PRODUCT CHANGE NOTIFICATION

Bourns® Model TISP4P0xxL1NR-S Series Overvoltage Protectors

Addition of Second Assembly and Test Manufacturing Location

Typical Part Marking

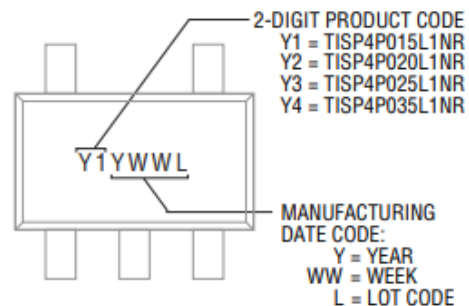
The part marking will be used to identify units produced at the new assembly and test manufacturing site. The lot code (L) of the new site will follow alphabetic characters while the current site will continue to use numbers.
